THE MARYLAND-NATIONAL CAPITAL PARK AND PLANNING COMMISSION

Item # 13
MCPB 11-20-03

MEMORANDUM

REVIEW TYPE: Site Plan Review
CASE #: 8-03036
PROJECT NAME: Rock Spring Center
APPLYING FOR: Approval of a 351-unit residential high-rise building, a clubhouse and associated underground parking

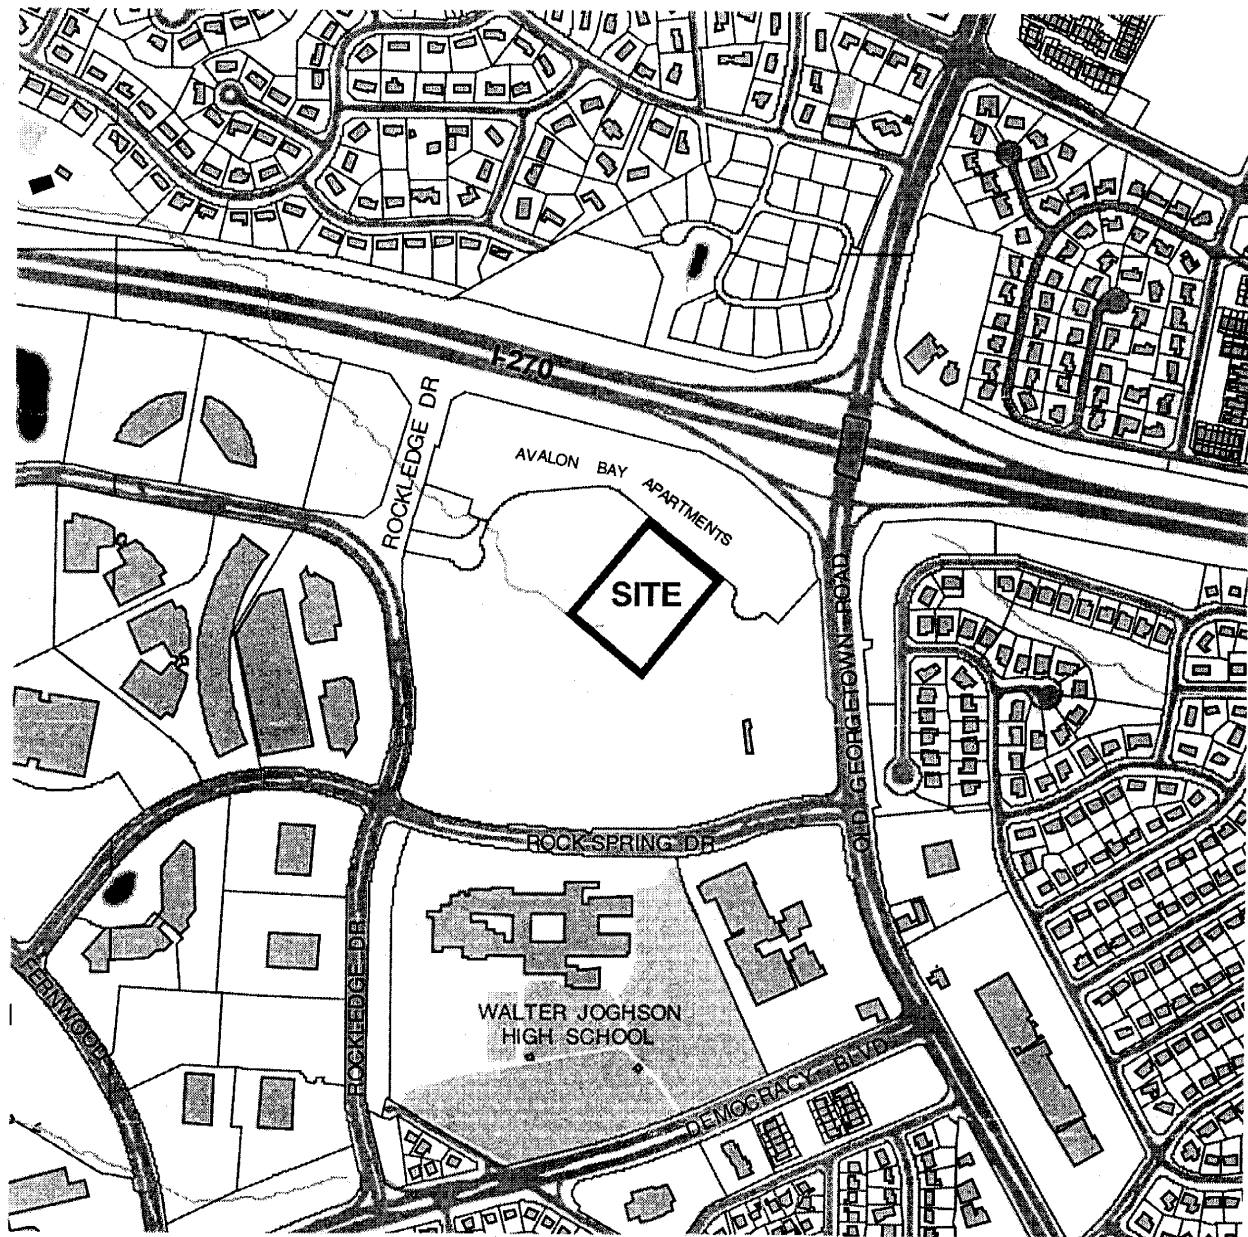
The proposed project is planned as a luxury high-rise residential development with its own indoor and outdoor amenities. The main building is set back 50 feet from the street. The main plaza level of the development is about 4 to 8 feet higher than the street and 9 to 16 feet higher than the green space behind the plaza. The plan proposes a sidewalk along the Rock Forest Drive frontage and an internal pathway system connecting building entrances with outdoor facilities and the public sidewalk. The plan also shows a 5-foot-wide sidewalk along

the east boundary of the site between Rock Forest Drive and the building's lobby exit doors on the its east side.

1. The proposed sidewalk along the east side of the building should be extended southwards to the southeastern corner of the site and connect with the future pathway system leading to the retail section of Rock Spring Center and the central green space.
2. A minimum 5-foot clearance (ADA requirements) should be maintained throughout the project's internal pedestrian pathway system to ensure safe and convenient pedestrian circulation.

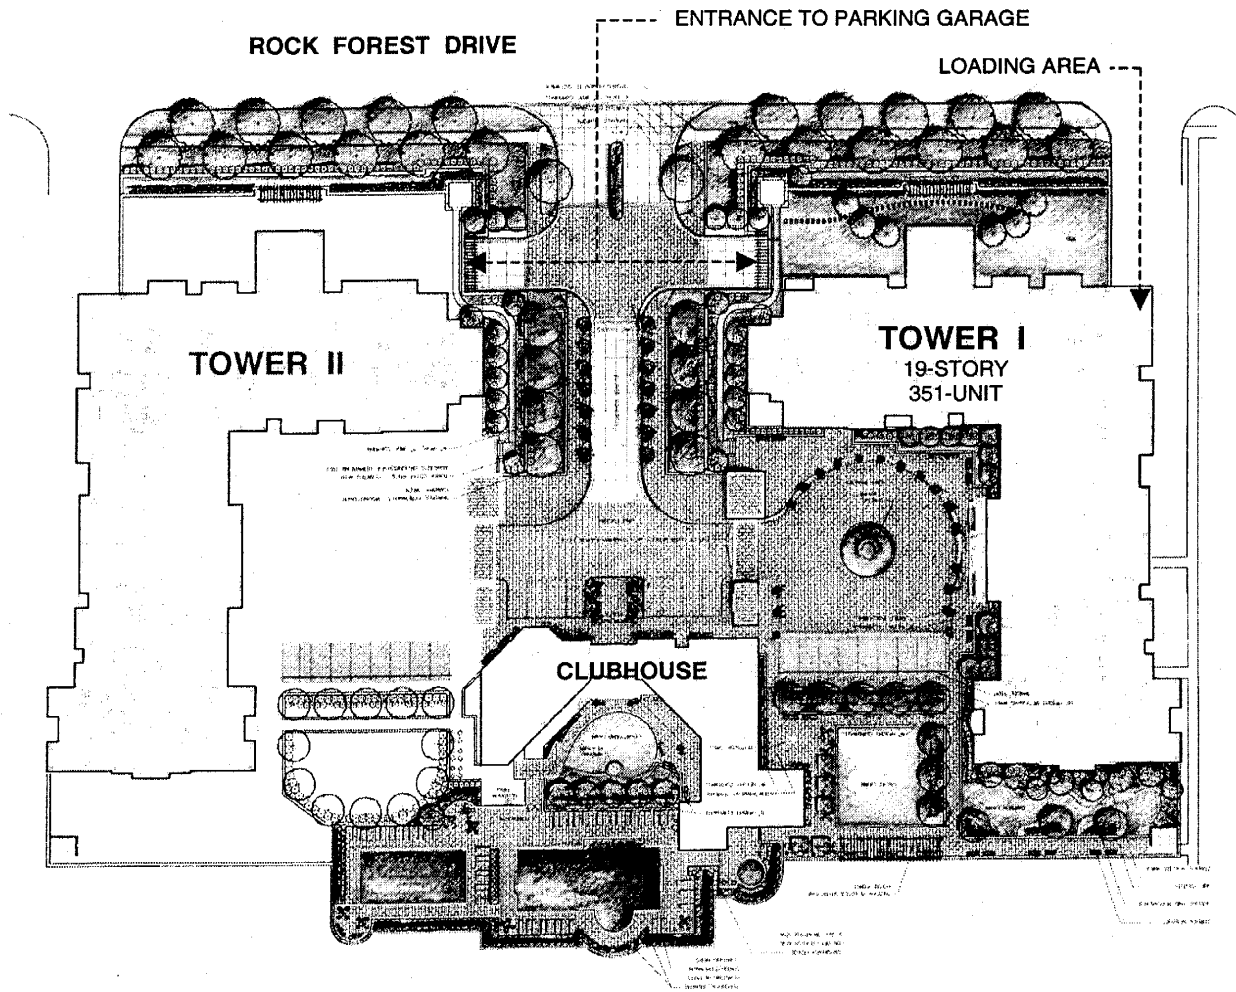
The proposed high-rise building is set back 50 feet from the street. The elevation difference between the building's ground floor and the street varies from 3.5 feet to near 8 feet. Landscaped berms will be provided between the sidewalk and the retaining walls. Shade trees are proposed along the street frontage and the entrance driveway. Recreation facilities will include landscaped green space, pathways, outdoor sitting and picnic areas, swimming pools, exercise rooms, media room, library, party room and meeting room. The leasing office will be located on the upper level of the clubhouse.

The proposed landscaping on the site consists of a mix of shade, evergreen and flowering trees along the street frontage, internal driveways, and around the proposed drop-off court and green space areas. A portion of the existing vegetation, about 0.33 acres, will be saved along the south boundary of the site. Additional plant materials are needed along the southern edge of the structure to provide adequate screening along the retaining walls.

The plan proposes various lights along the street and throughout the site, including streetlights on 13-foot-high poles, internal sidewalk lights on 11-foot-high poles, wall-mounted lights, and uplighting for landscaping. Additional lighting should be provided along the proposed sidewalk on the east side of the high-rise building.
